REGULAR MEETING OF THE
CITY OF CONCORD
DESIGN REVIEW BOARD

Thursday, November 12, 2015
5:30 p.m., Regular Meeting
PERMIT CENTER CONFERENCE ROOM
1950 Parkside Drive, Bldg. D

MEMORANDUM

1 / A3.1 WEST ELEVATION
SCALE: 1/4" = 1'-0"

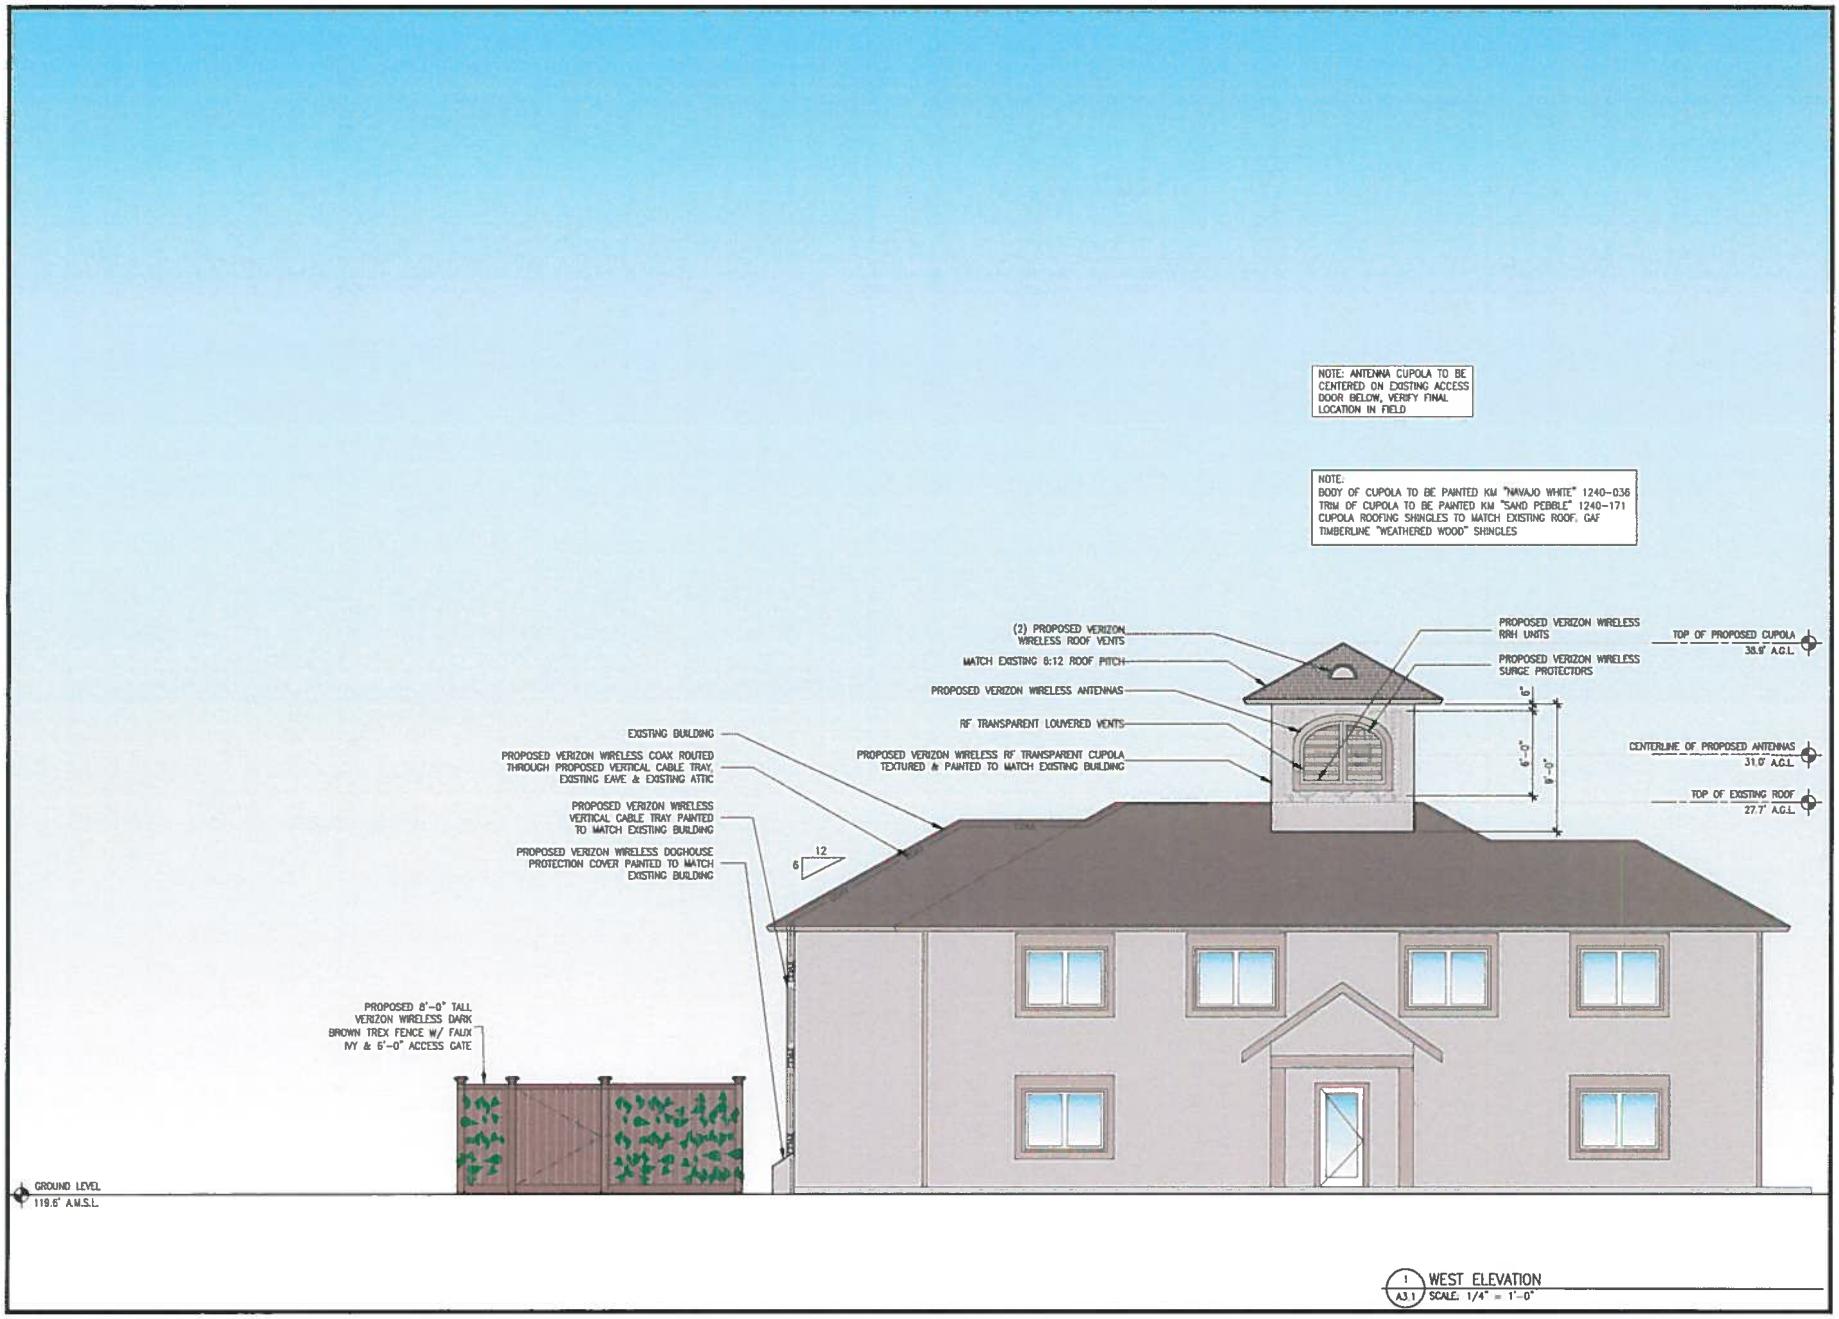
- Preference towards the squared louver design as it is consistent with the existing architecture.
- Add a base to the cupola design or trim to the base of the cupola.
- Preference towards landscaping with live plant material such as a trellis.
